Bid Bulletin #01

PROJECT: Skinner Early Childhood Center
Bid Package #4
Omaha, NE

ADDENDUM E

Skinner Early Childhood Center
Omaha, Nebraska
RDG Project No. 2014.128.00, File 35.1

Project Number: 2014.128.00	Date: 11/21/14	Change to Sheet:	Drawing: E6.1	SDE-004
	SKINNER EARLY CHILDHOOD CENTER				BUFFETT EARLY CHILDHOOD FUND
ADD-E

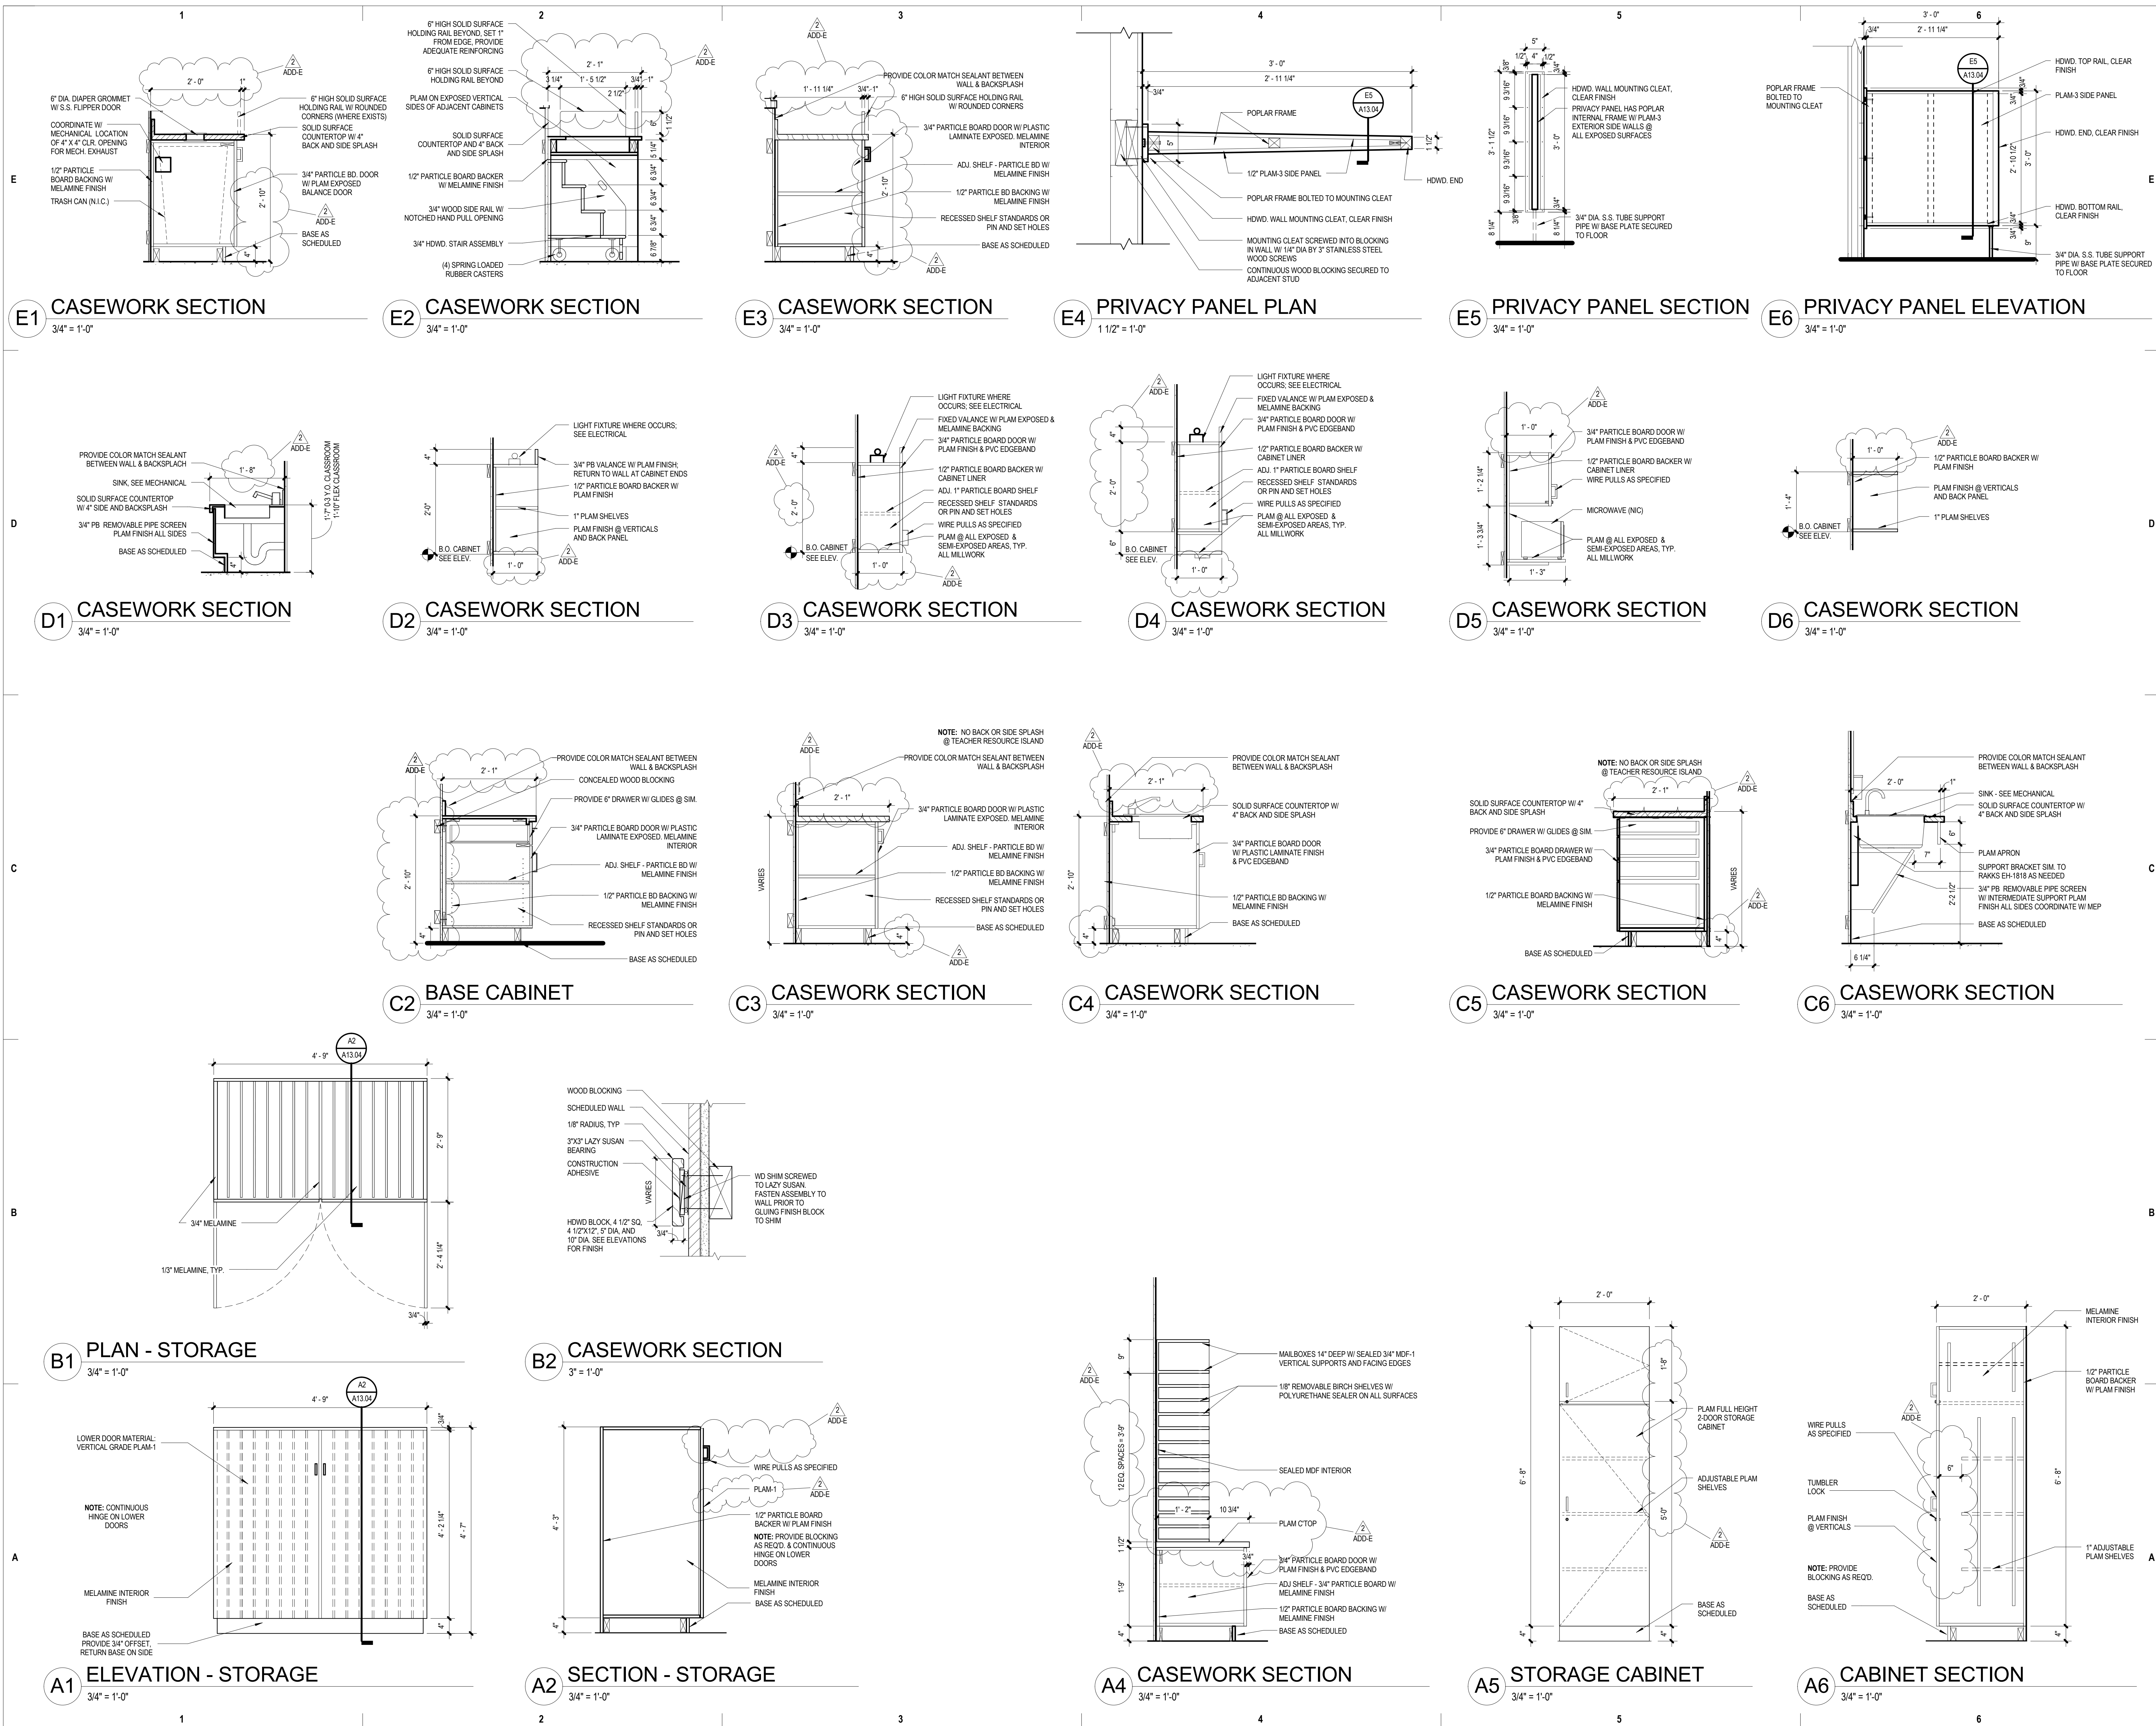
EED-4 Sheet E6.1 – Electrical Schedules: Revise Panel Schedule 'M' to reflect changes to HP-25. The circuit breaker for HP-25 is now 35/3. See attached Supplemental Drawing SDE-004.

MILLWORK DETAILS

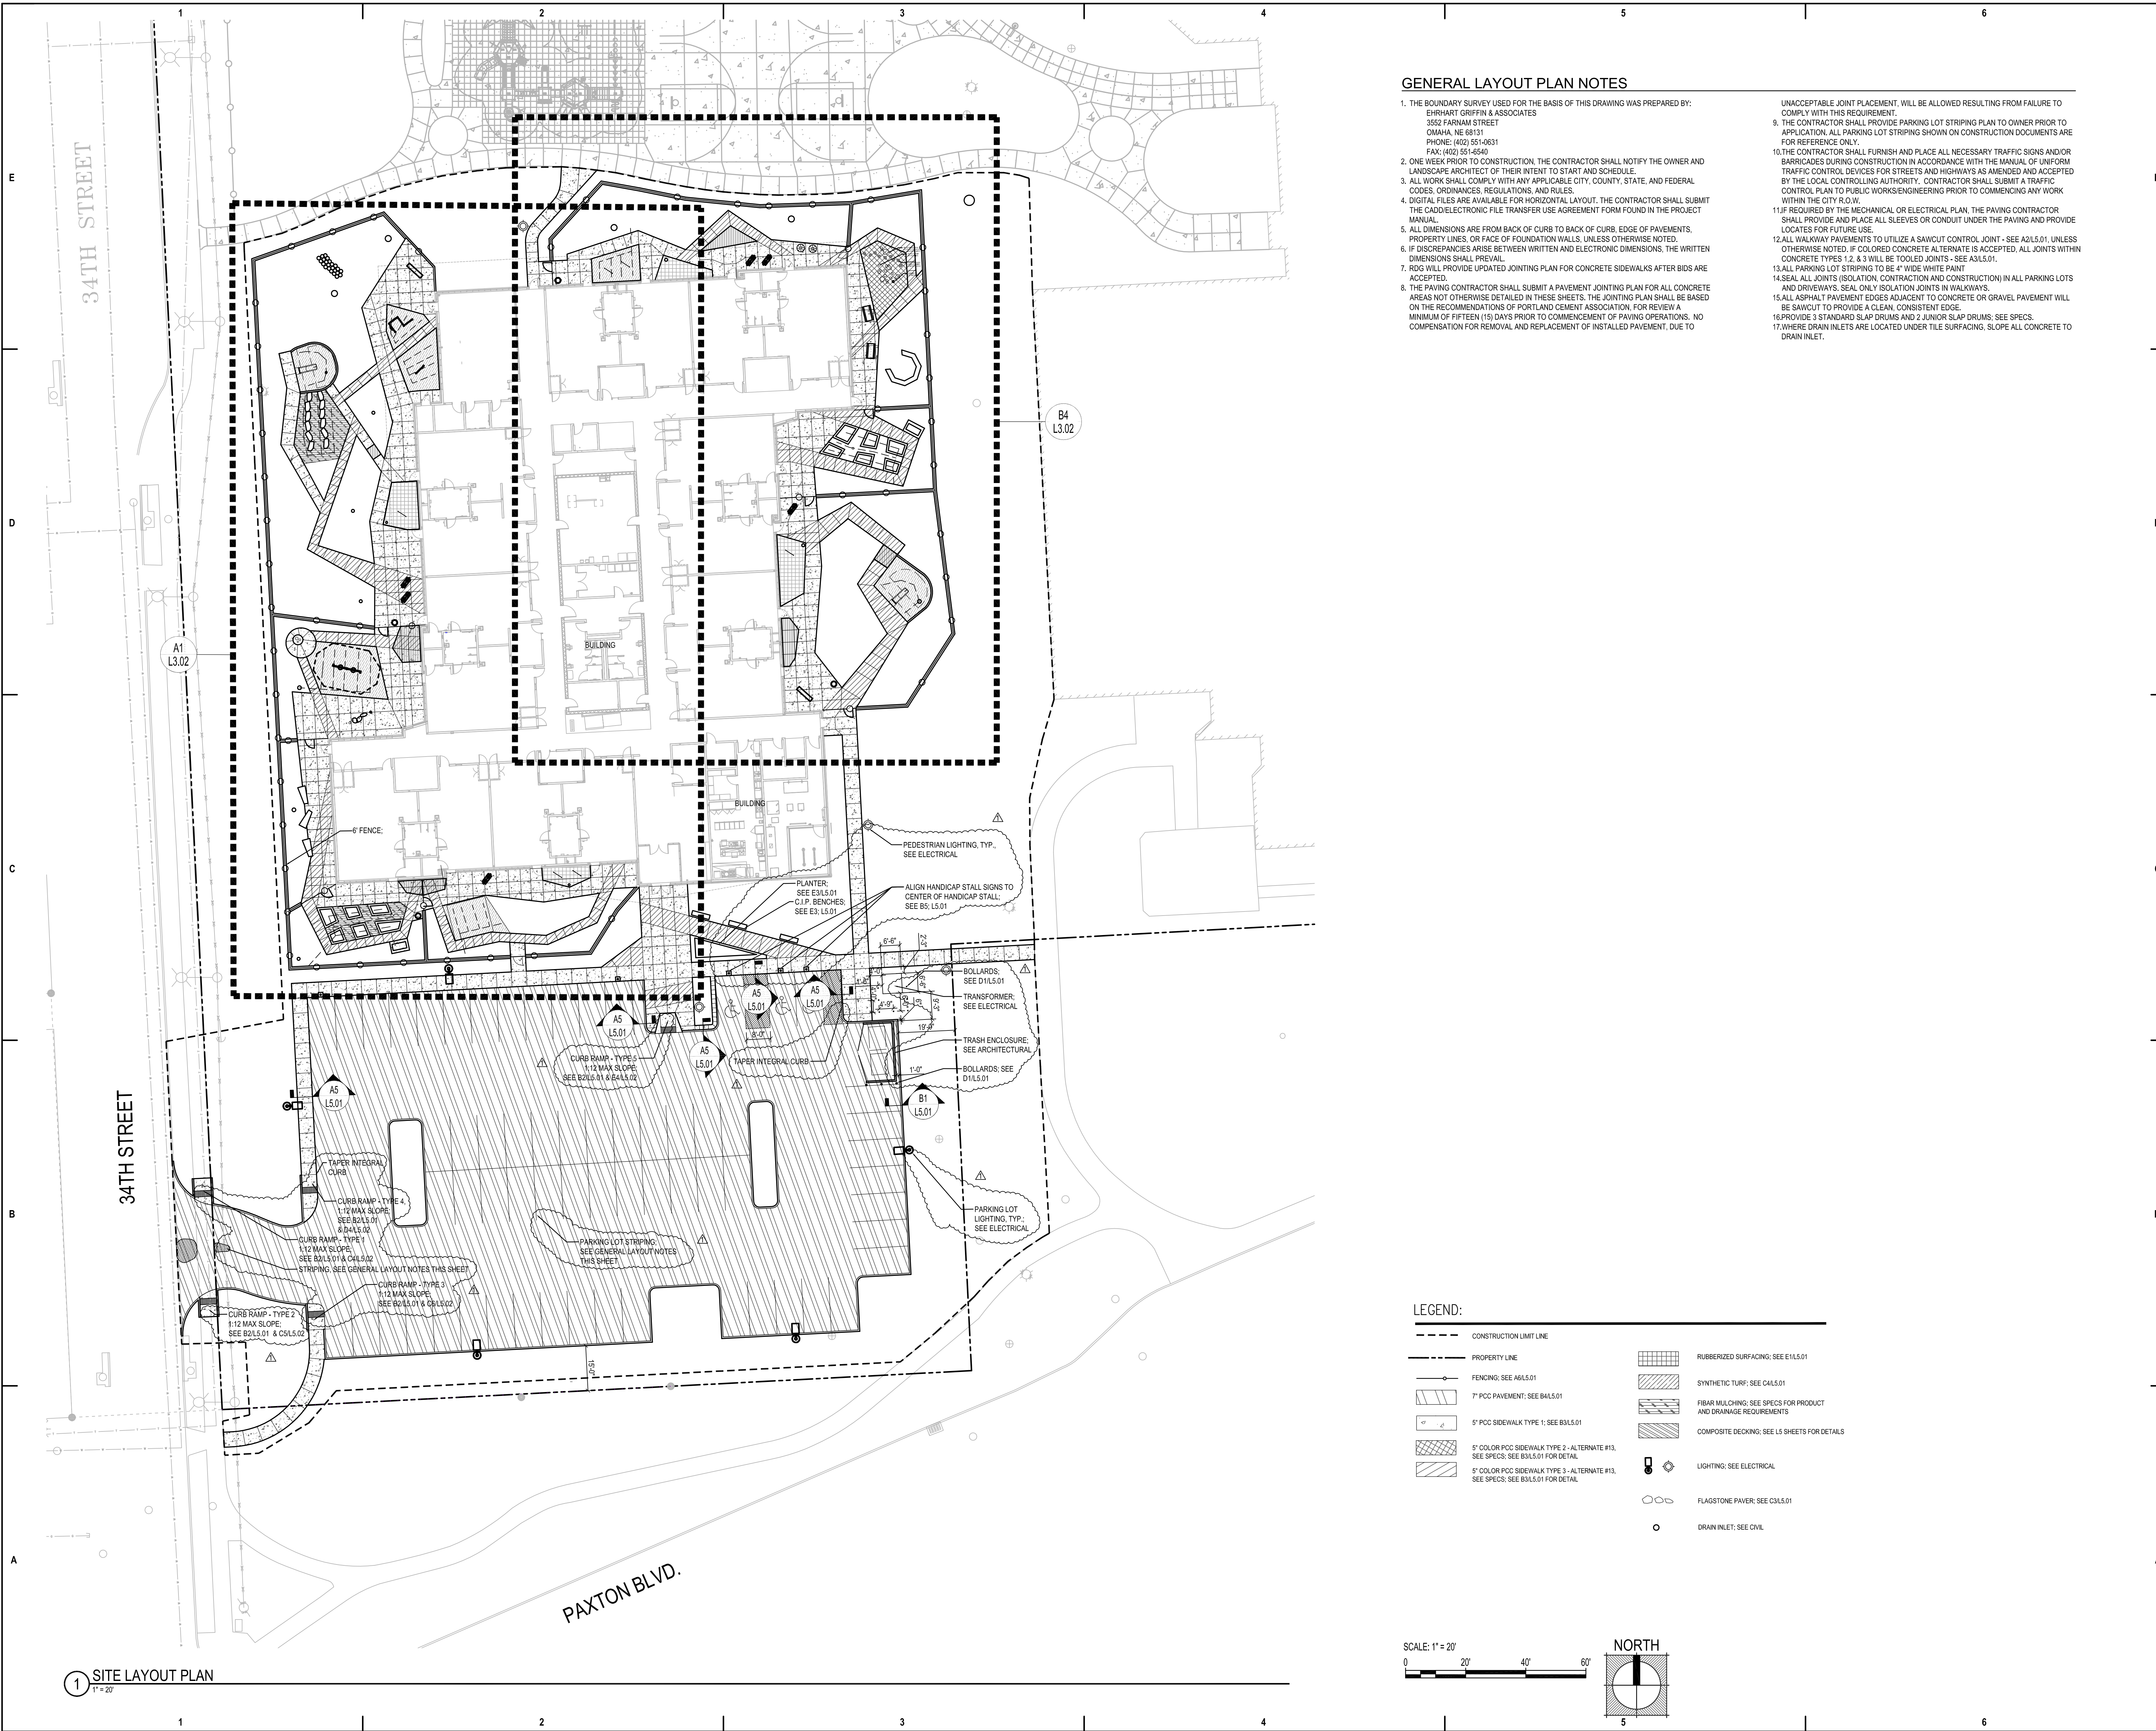
Sheet A13.04 – Millwork Details, Details A4, A5, A6, C2, C3, C4, C5, D1, D2, D3, D4, D5, D6, E1, E2, and E3: Provide dimension and note updates as shown. Completely replace Sheet A13.04 in its entirety.

1 SITE LAYOUT PLAN
1" = 20'

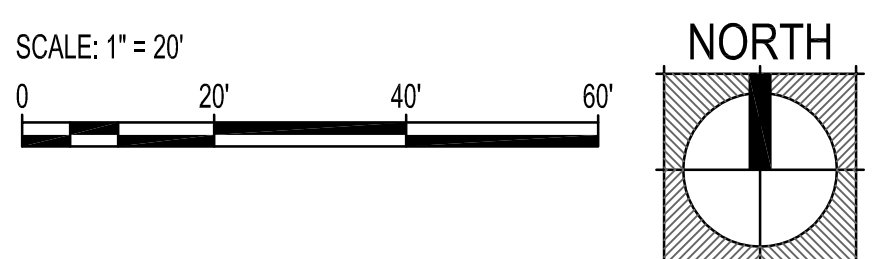
ELD-1 Sheet L3.01: Add text notes as clouded on Site Layout Plan. Replace sheet in its entirety with updated Sheet L3.01 dated 11-21-2014.
